SHOAL CREEK ADDITION WICHITA, SEDGWICK COUNTY, KANSAS

RE: SUB 2000-22 -- Final Plat of SHOAL CREEK ADDITION (FORMERLY WHITEWOOD ADDITION)

At the regular meeting of the Subdivision Committee of the Metropolitan Area Planning Commission on Thursday, September 14, 2000, the above captioned plat was considered. The action of the Committee was to approve the final plat, subject to the following:

CASE NUMBER: SUB 2000-22 --SHOAL CREEK ADDITION (formerly Whitewood Addition)

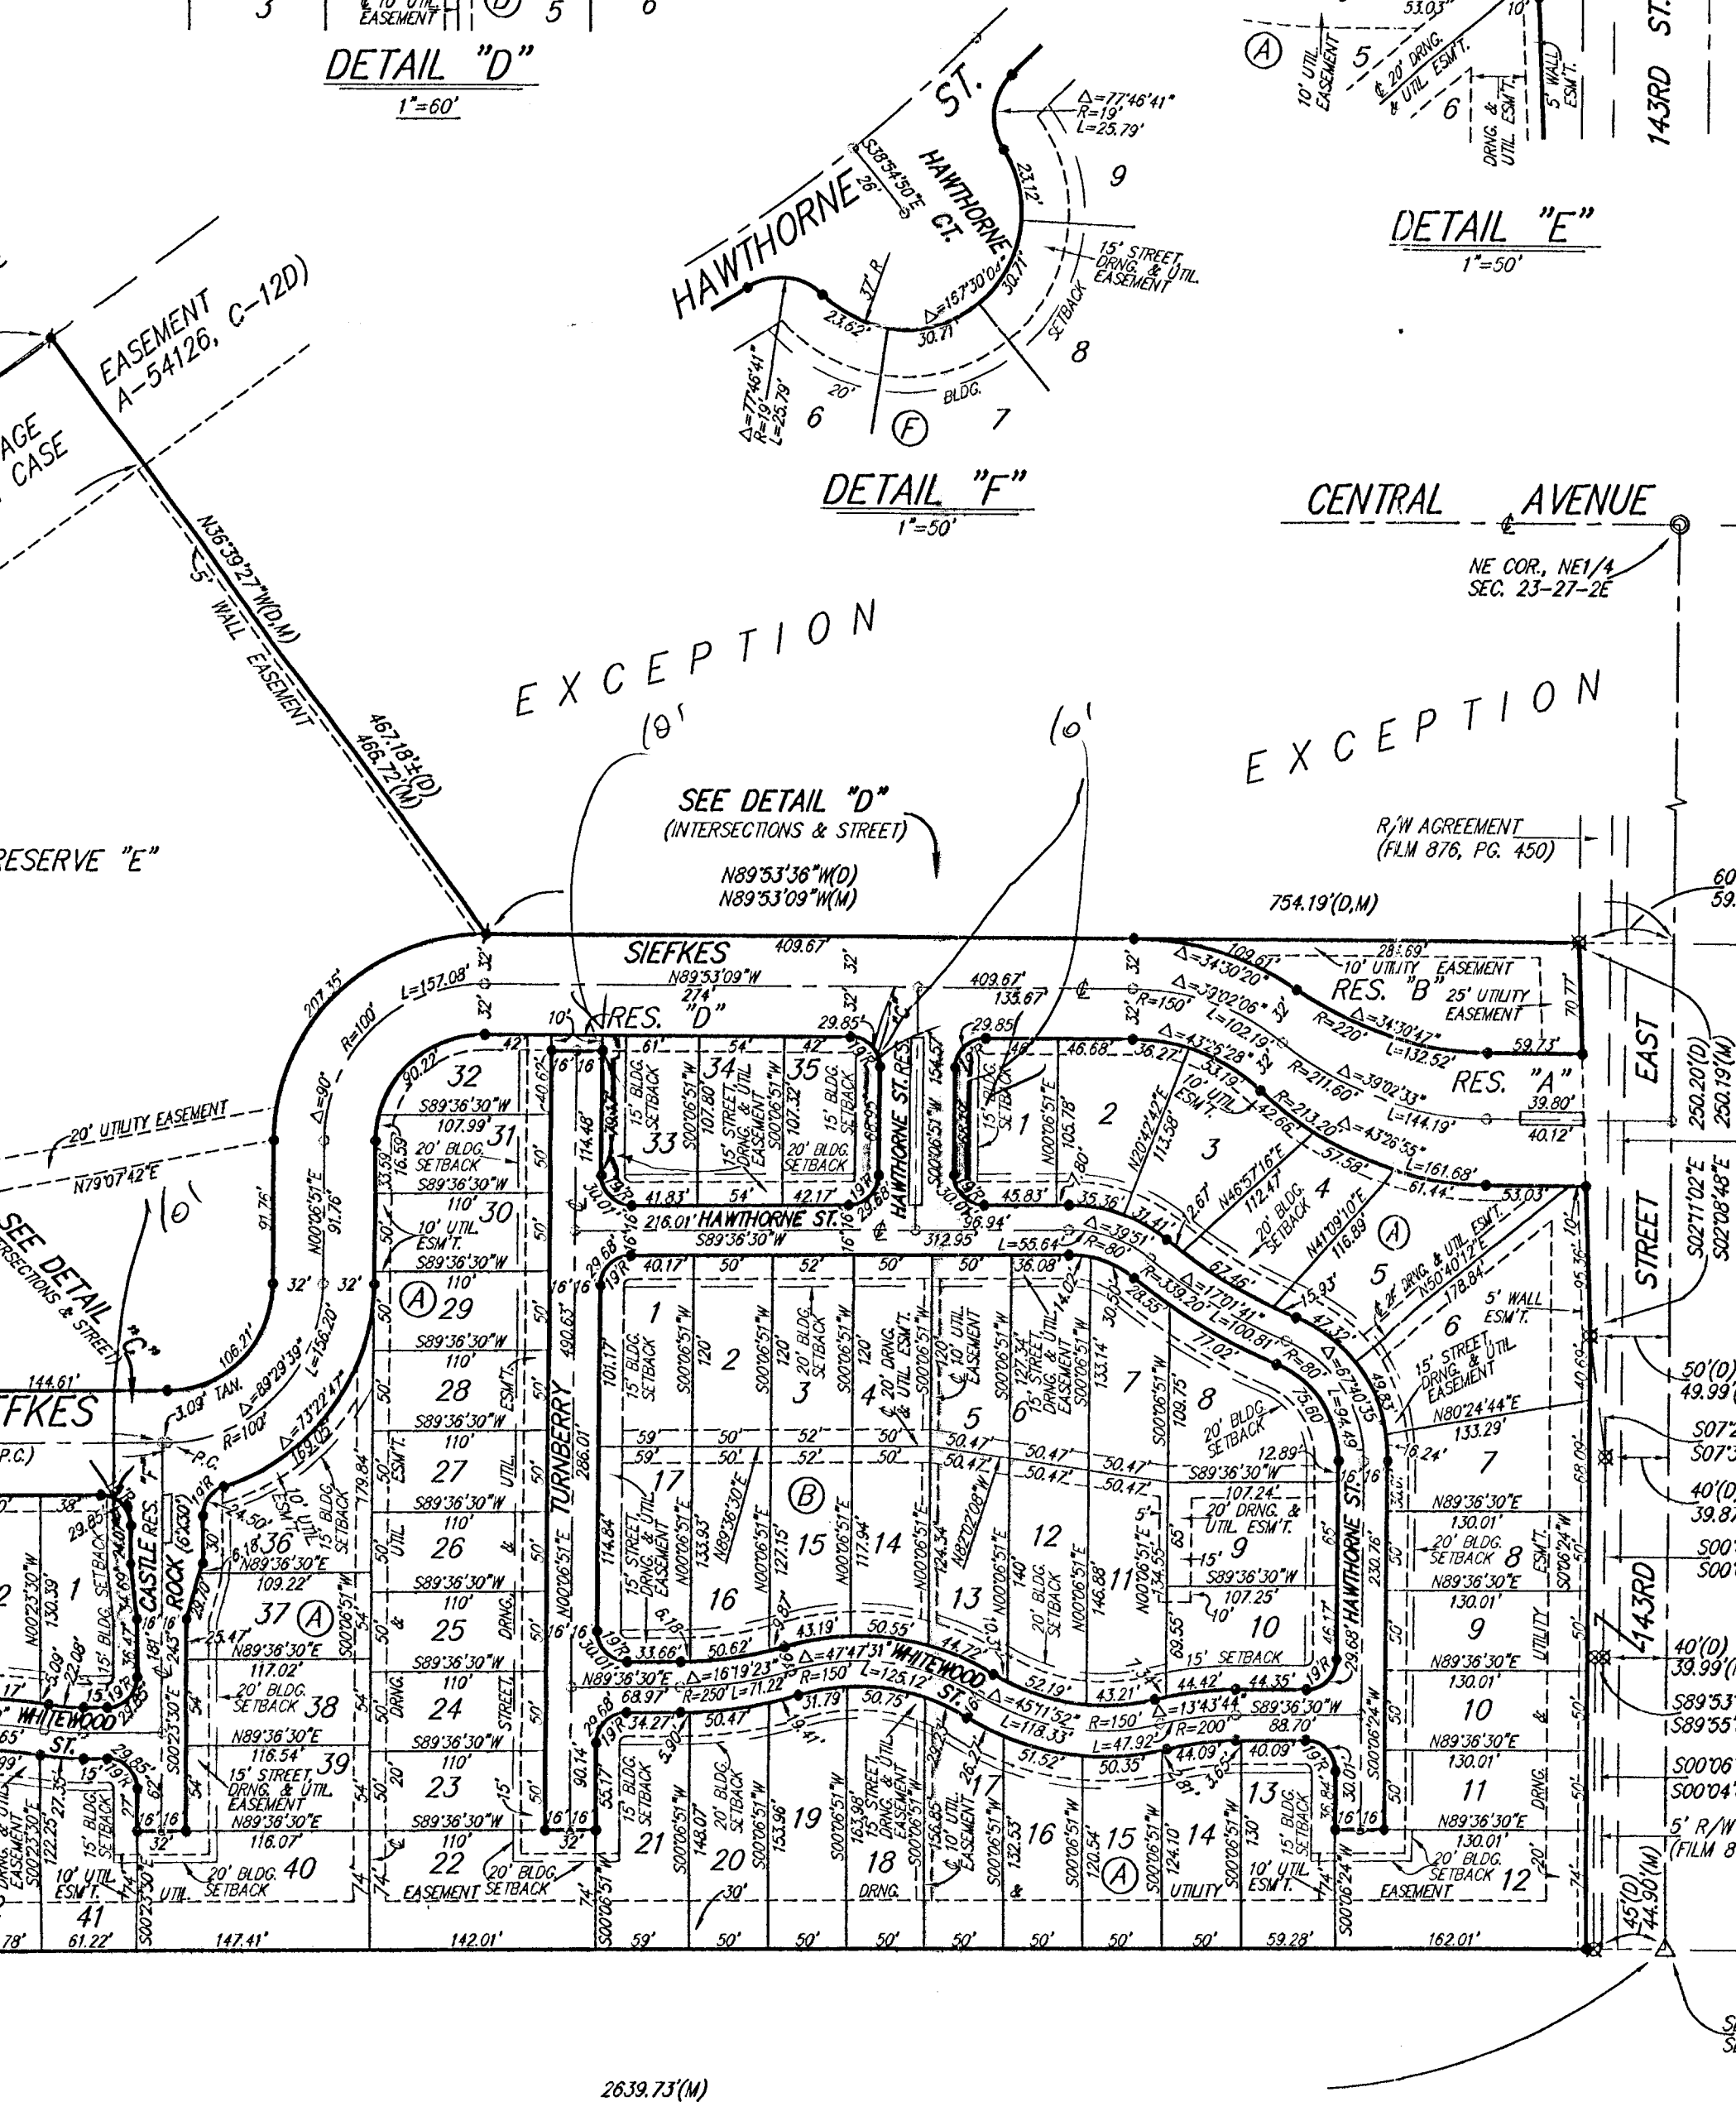
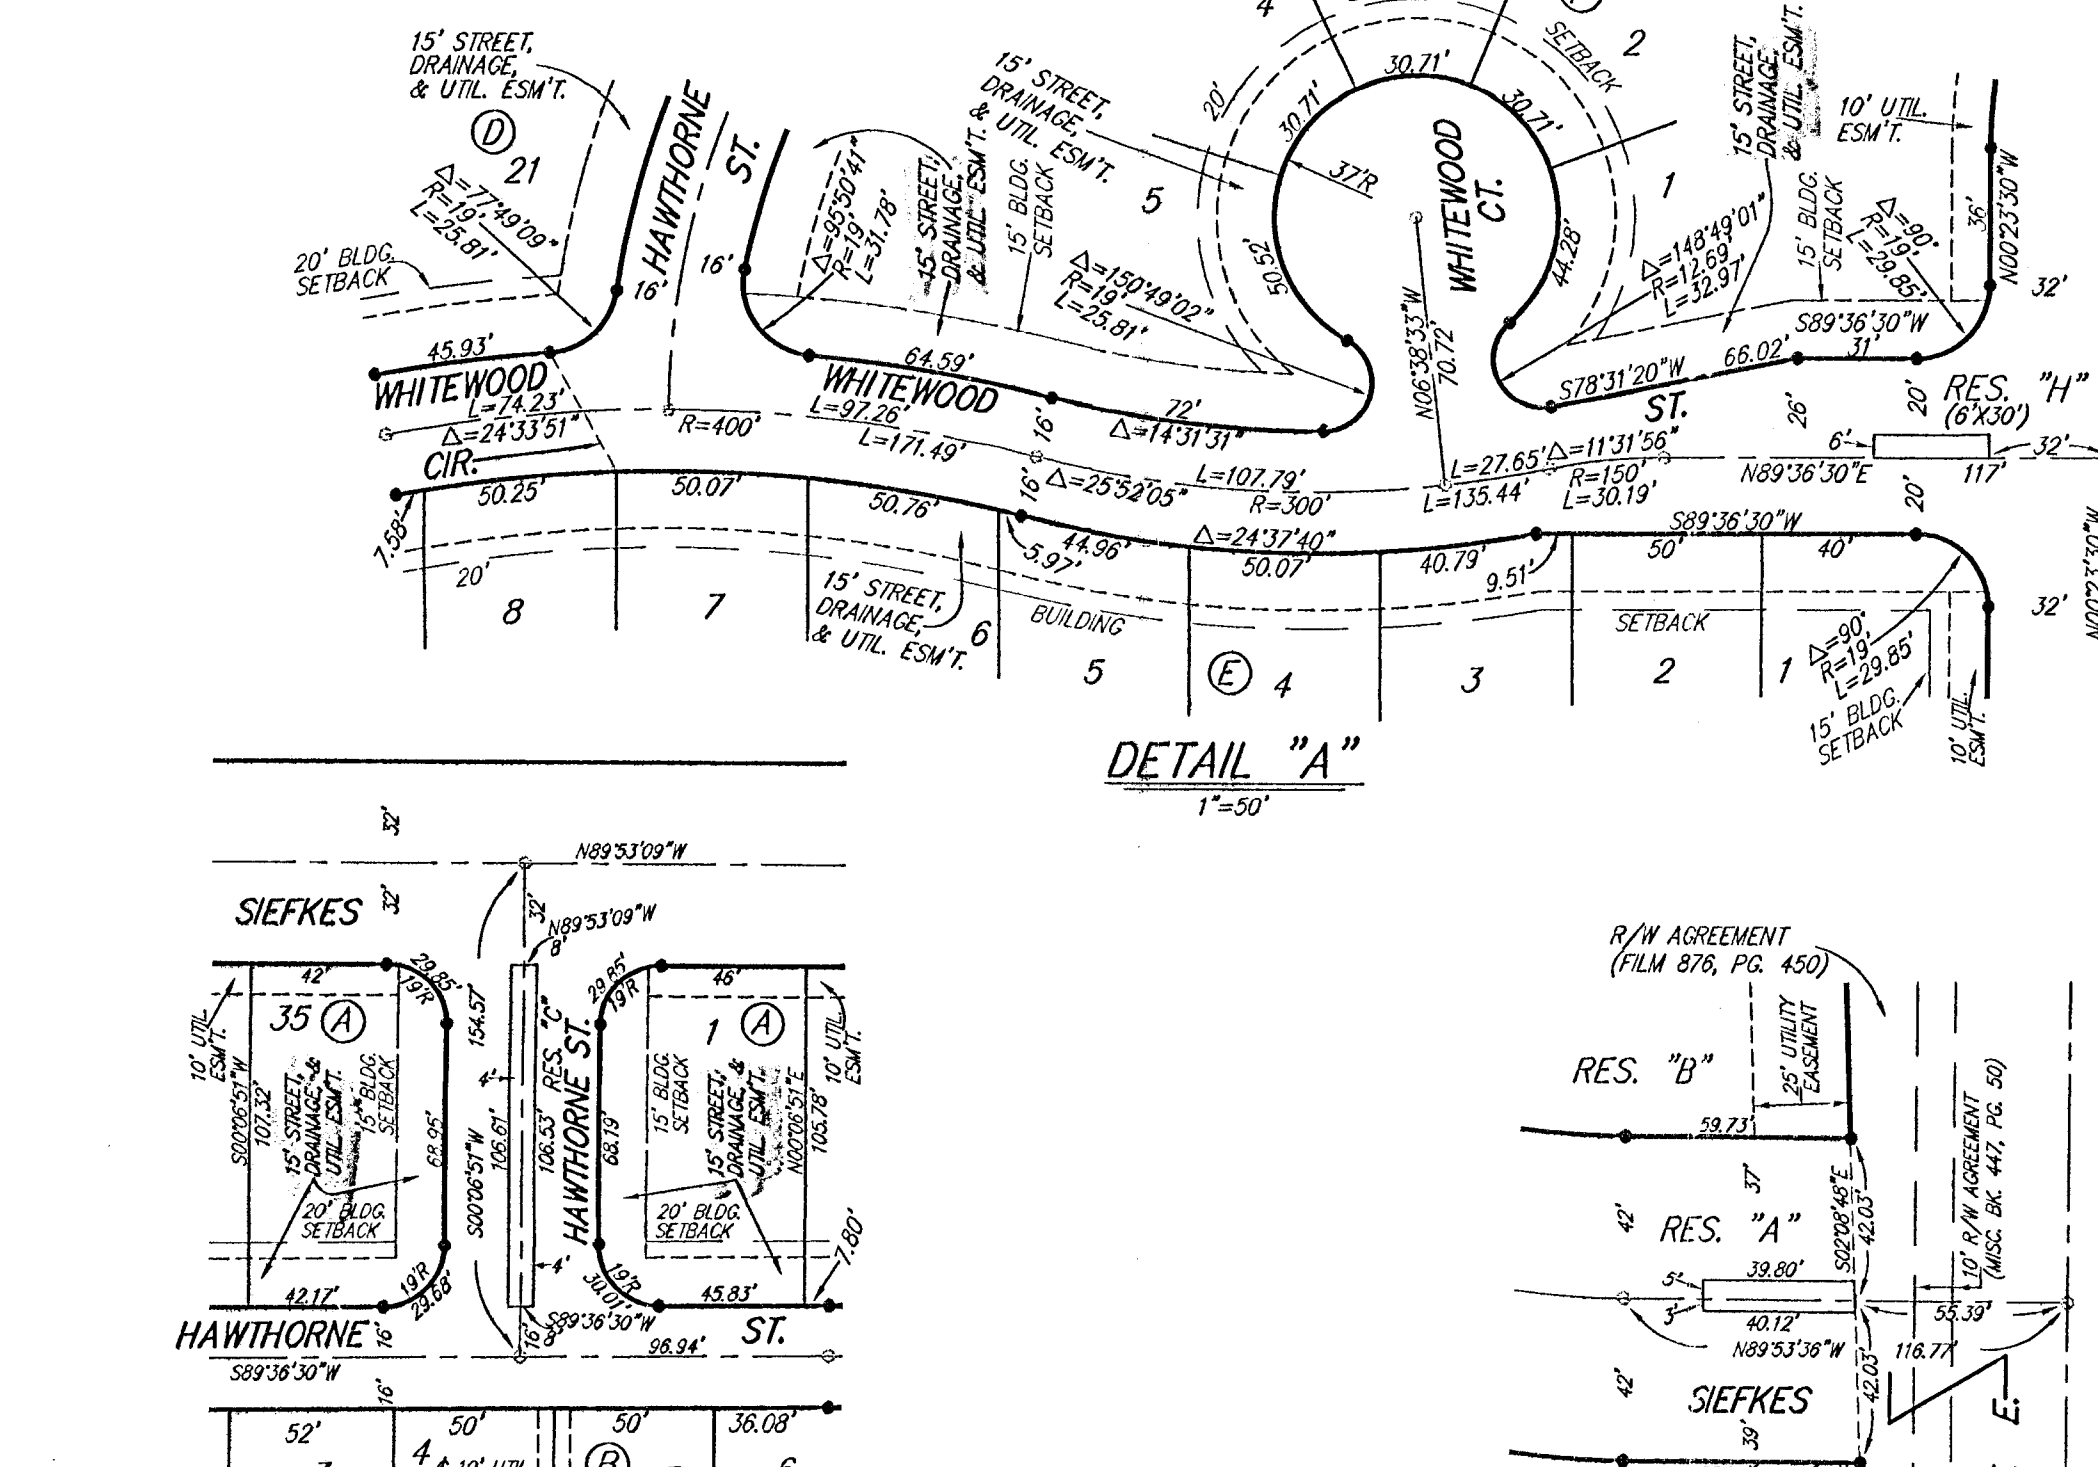
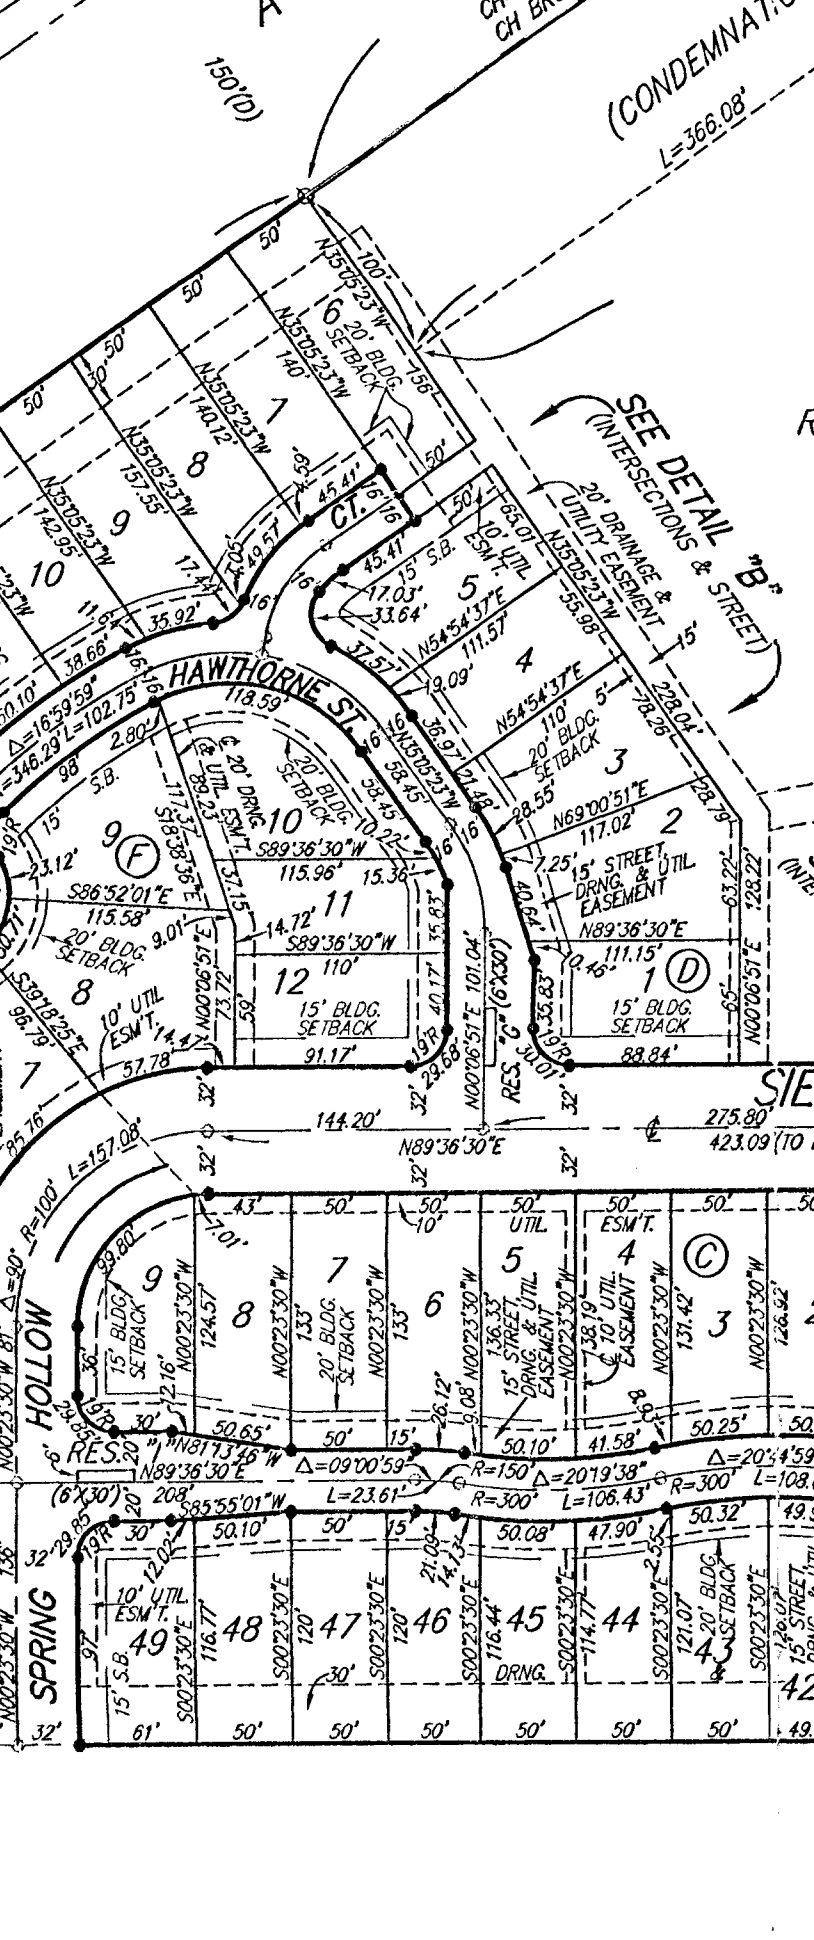
- B. The applicant shall guarantee the extension of sanitary sewer to serve the lots being platted. This guarantee shall be with the County for service through the Four Mile Creek sanitary sewer system. On the final plat tracing, appropriate wording shall be added to the Mayor's signature block indicating the City's agreement to allow a County sewer district to be formed within the City. **A revised sanitary sewer/utility layout is requested. Off-site sewer easements are required.**

- E. **City/County Engineering** needs to comment on the status of the applicant's drainage plan. **A drainage guarantee is required. As drainage from the site is directed onto the Kansas Turnpike, a letter shall be required from KDOT indicating their agreement to accept such drainage.**

- G. City Fire Department needs to comment on the 2,400-ft cul-de-sac (Siefkes/Whitewood Court) which exceeds the 1,200 maximum length standard of the Subdivision regulations. City Fire Department requests an emergency access easement to provide two points of access along Reserve D, Block A.

- K. The MAPC Policy Statement regarding Cluster Development states that each open space area shall be a minimum of 10,000 square feet and that no lot reduced in area shall be more than 500 feet from the nearest open space area. Lots 36-39, Block E are not located within the required 500 feet from Reserve E. A modification from this design standard has been approved.

- M. The lots in Block E shall be renumbered beginning with Lot 1.
- N. The terminus of Whitewood Court to the west shall be reconfigured as a circular turnaround.

- Q. The pipeline easement on Lot 26, Block E, needs to be located.
- R. A dimension needs to be added on Lots 5 and 6, Block D.

- S. Since this plat proposes the platting of narrow street right-of-way with adjacent "15-foot street drainage and utility easements", a restrictive covenant shall be submitted which calls out restrictions for lot-owner use of these easements. Retaining walls and change of grade shall be prohibited within these easements as well as fences, earth berms and mass plantings.

- T. City Fire Department needs to comment on the plat's street names. The City Fire Department has met with the Applicant to revise the street names.
- U. The applicant shall guarantee the installation of the interior streets. This guarantee shall include a sidewalk along one side of Whitewood/Siefkes. In lieu of sidewalks on Siefkes Court and Whitewood Place/Whitewood Court, the Applicant has agreed to submit an alternate sidewalk plan denoting sidewalks around Reserve E.

- V. The applicant shall submit a covenant which provides for four (4) off-street parking spaces per dwelling unit on each lot which abuts a 32-foot street. The covenant shall inventory the affected lots by lot and block number and shall state that the covenant runs with the land and is binding on future owners and assigns.
